# **HUNTS POINT INTERSTATE ACCESS IMPROVEMENT PROJECT – CONTRACT 3**

**PIN X731.65, Contract D900055**

**Addendum #6**

**July 1, 2022**

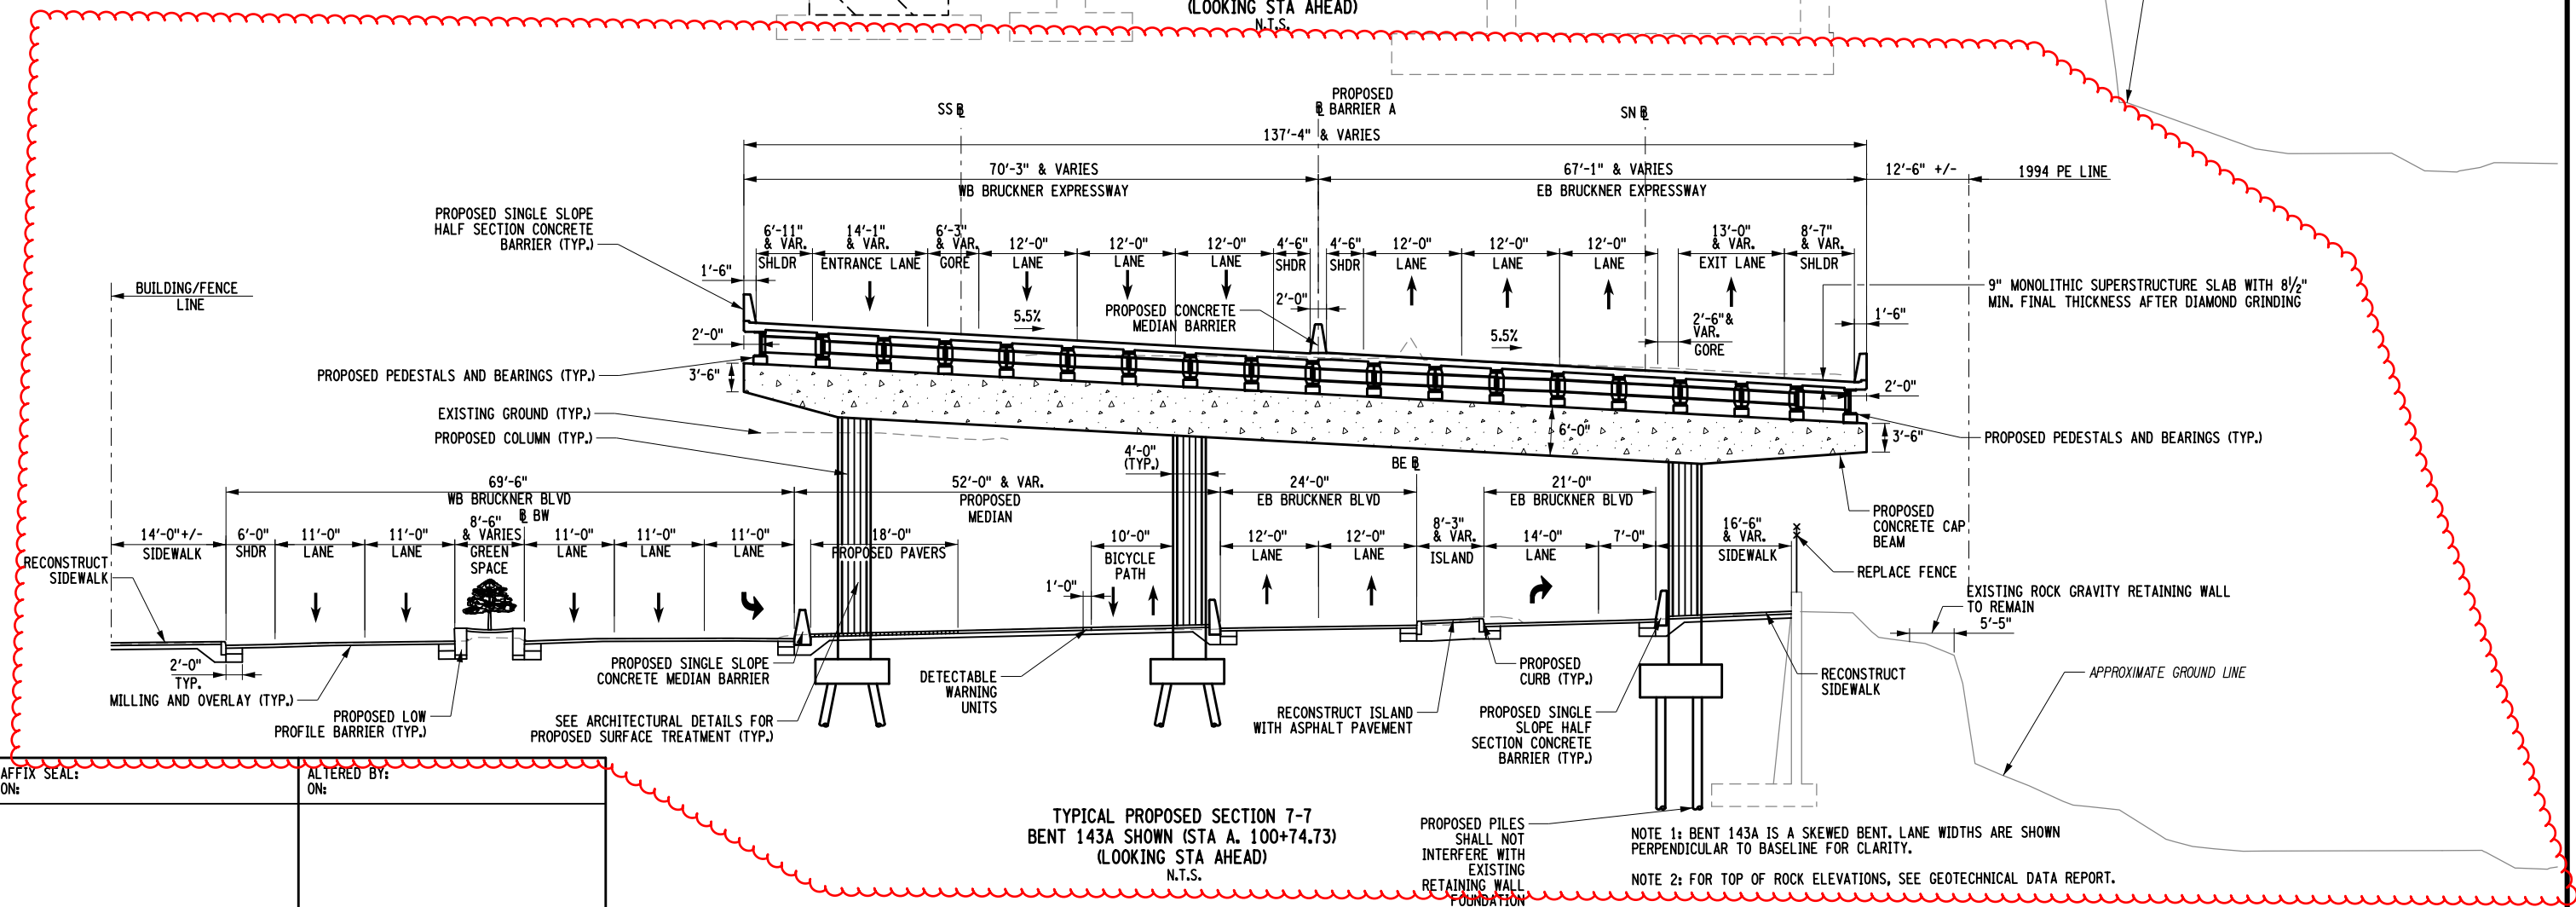
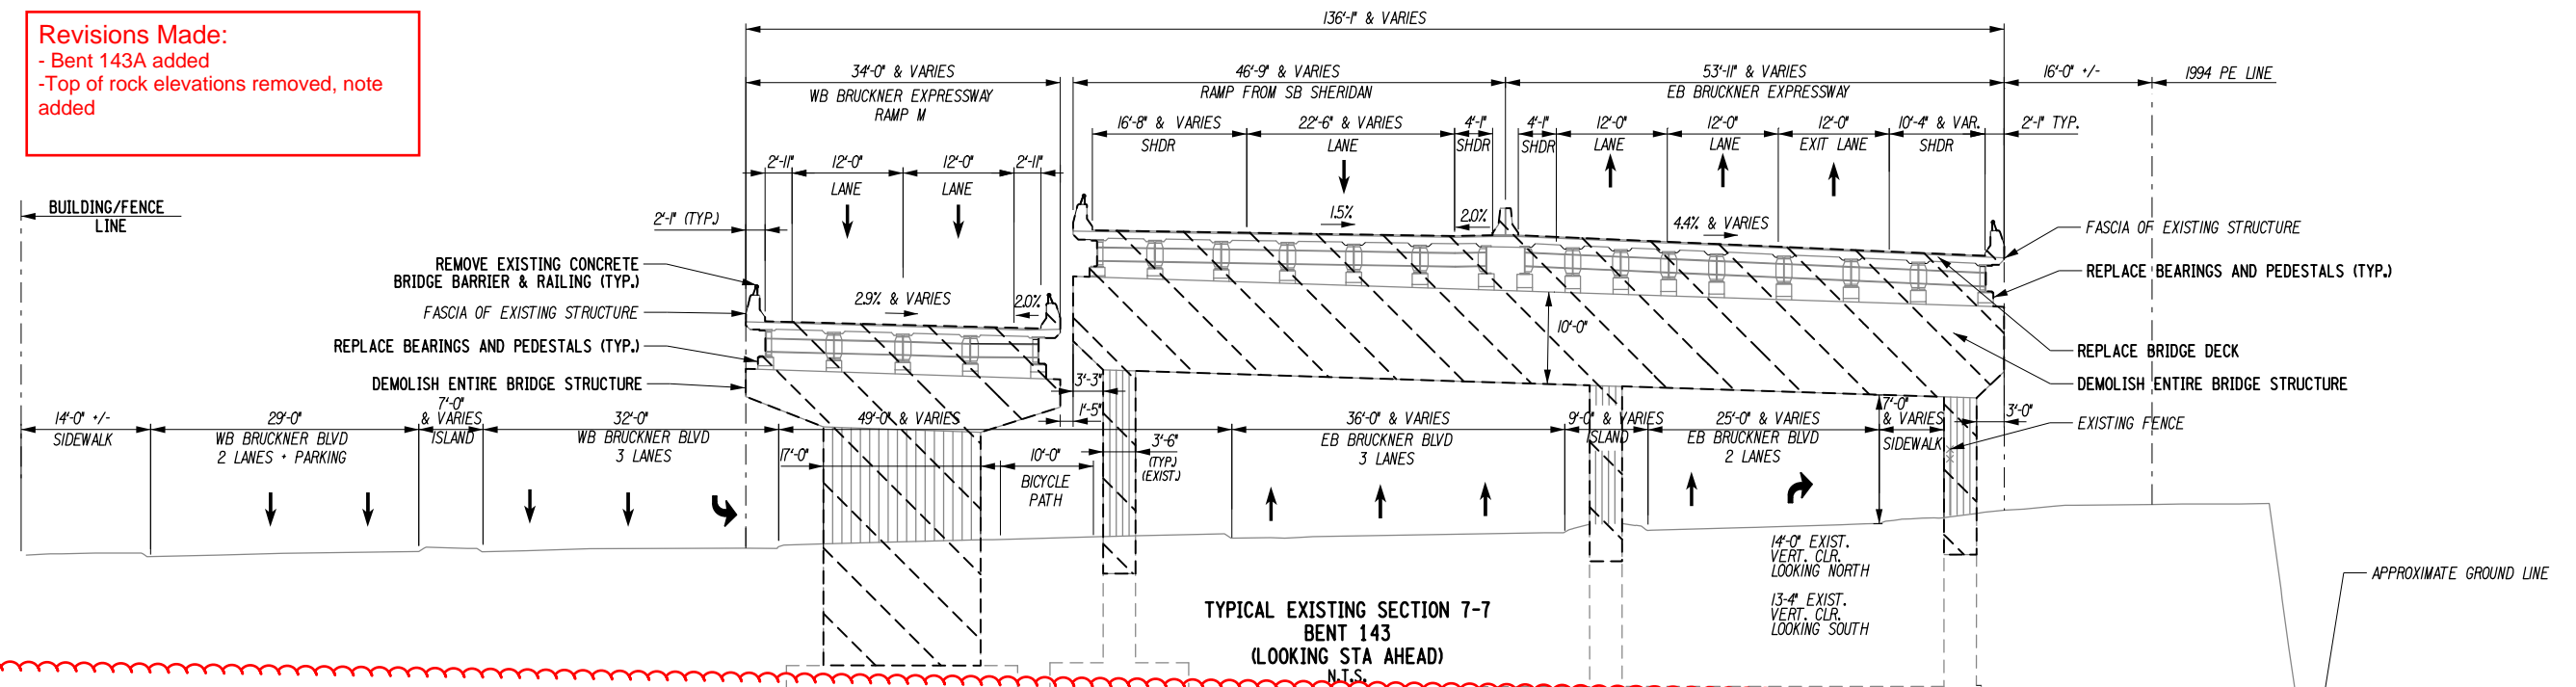
- Bent 143A added
- Top of rock elevations removed, note added

PROPOSED PILES SHALL NOT INTERFERE WITH EXISTING RETAINING WALL FOUNDATION

NOTE 2: FOR TOP OF ROCK ELEVATIONS, SEE GEOTECHNICAL DATA

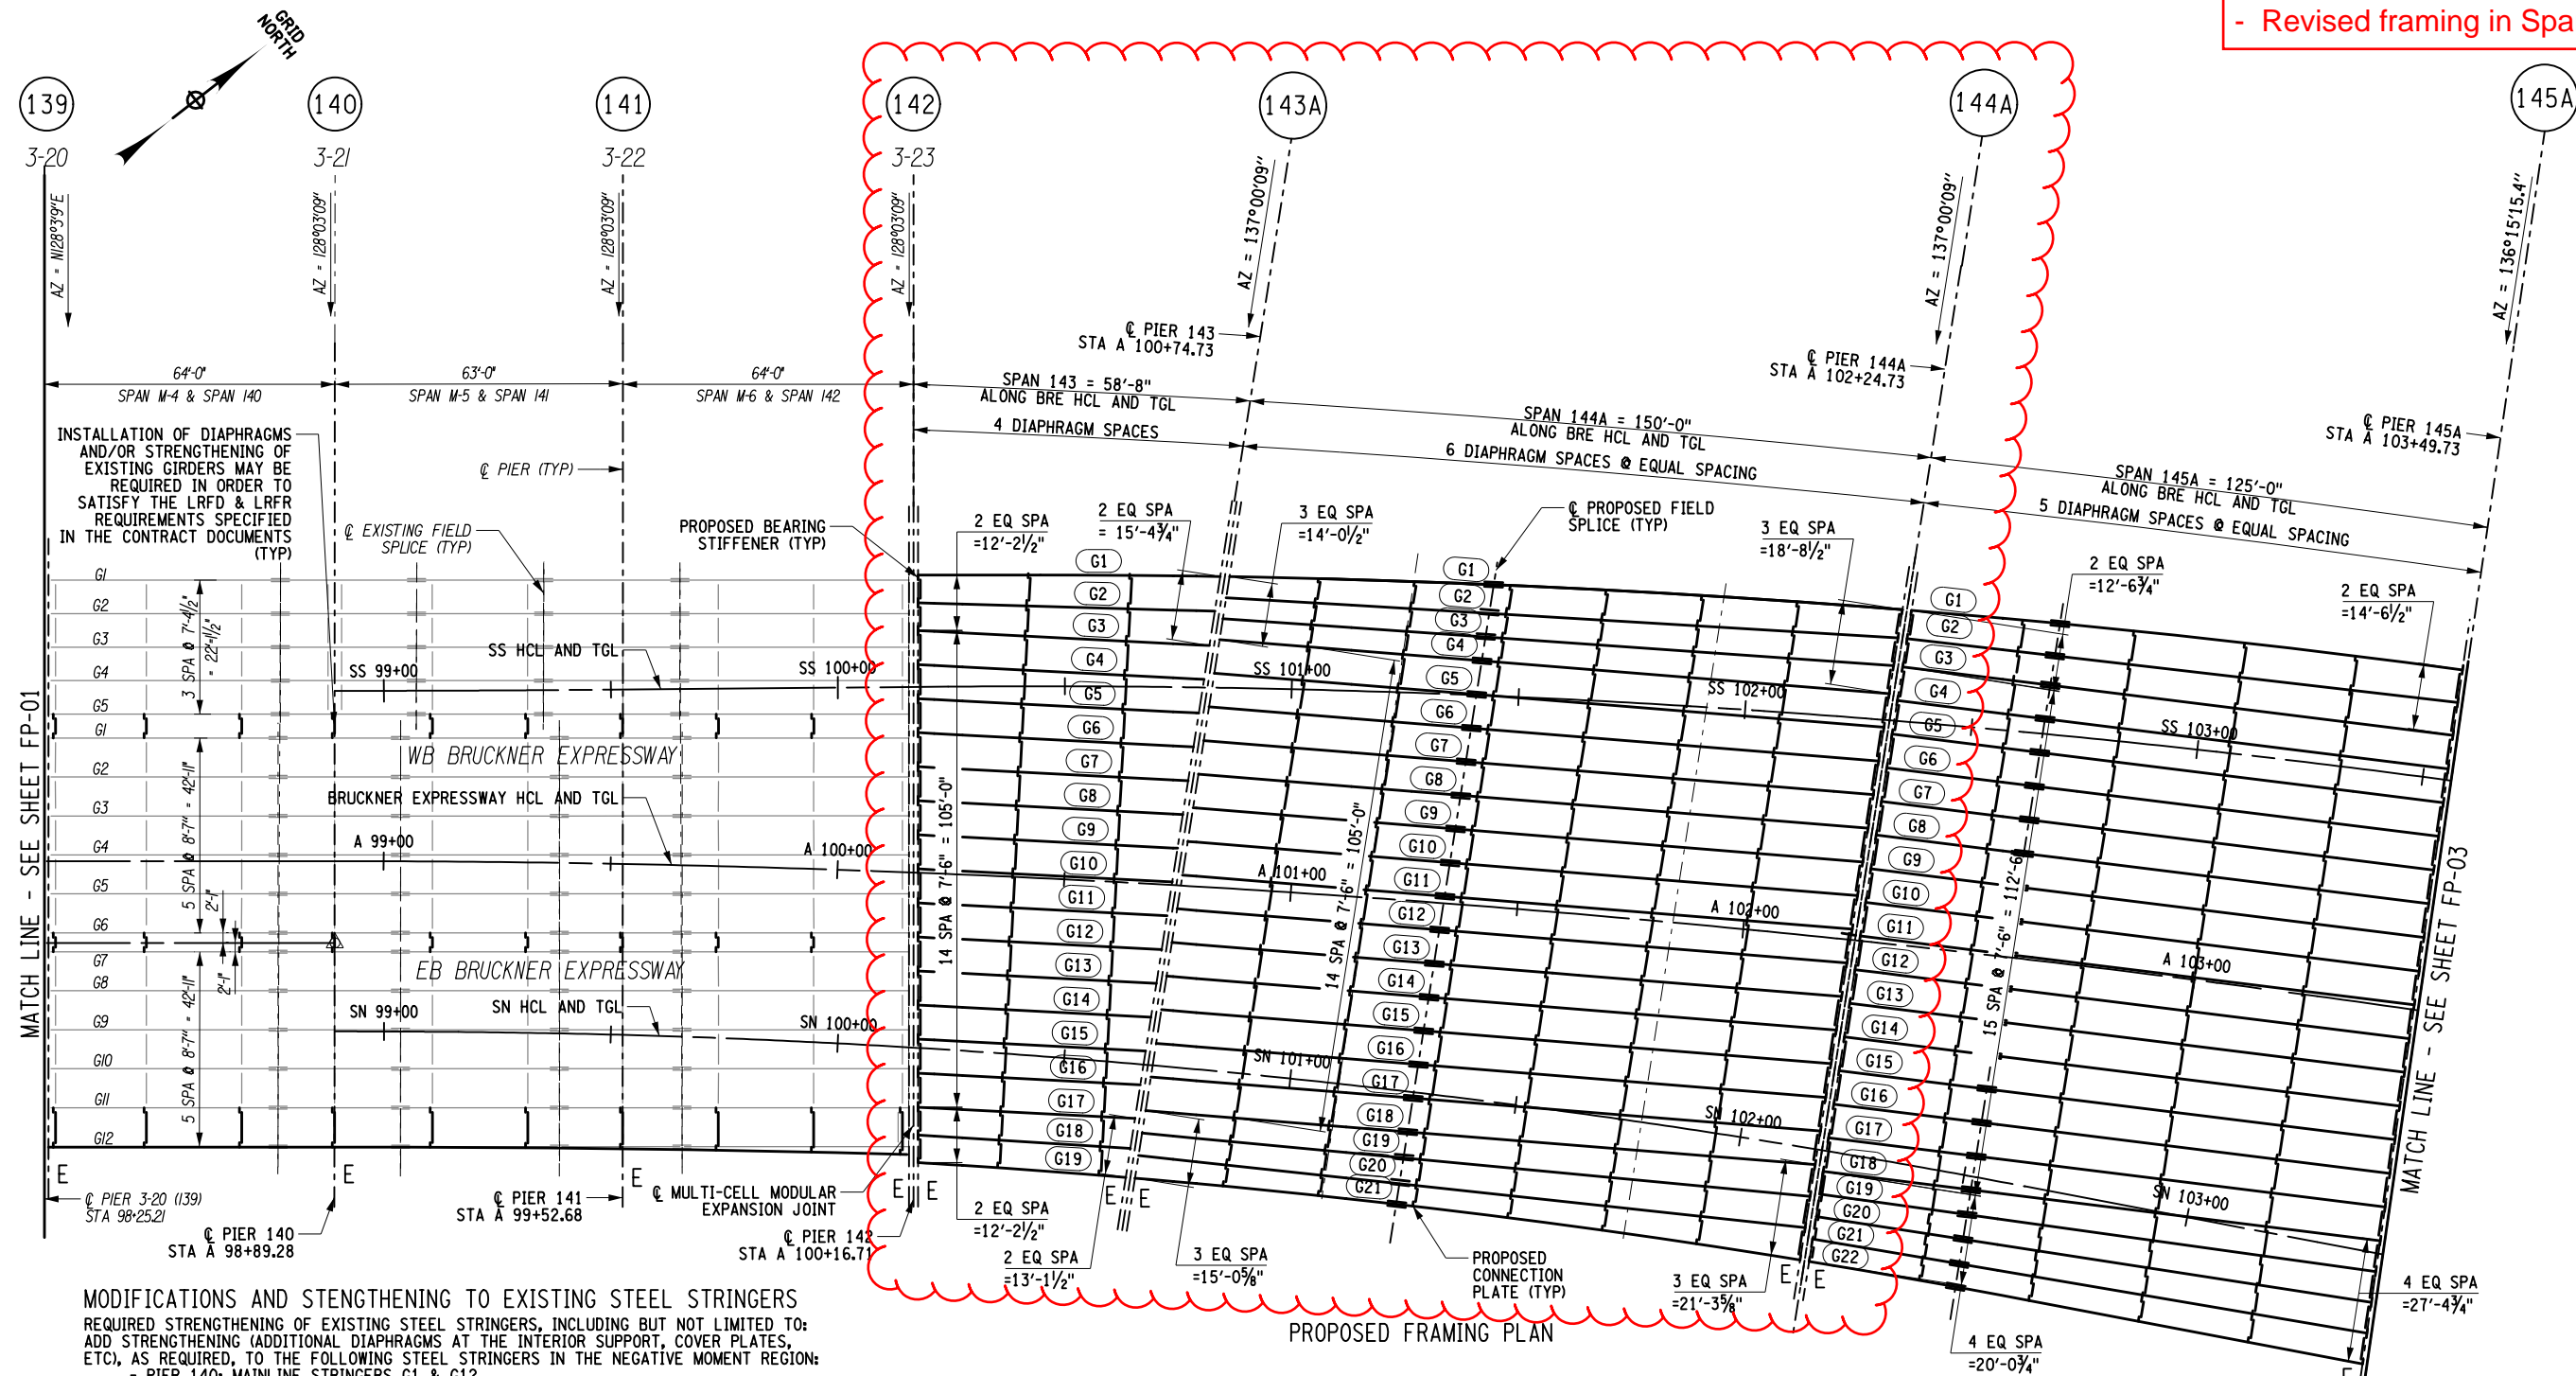
- New Pier 143A
- Revised framing in Spans 143 and 144
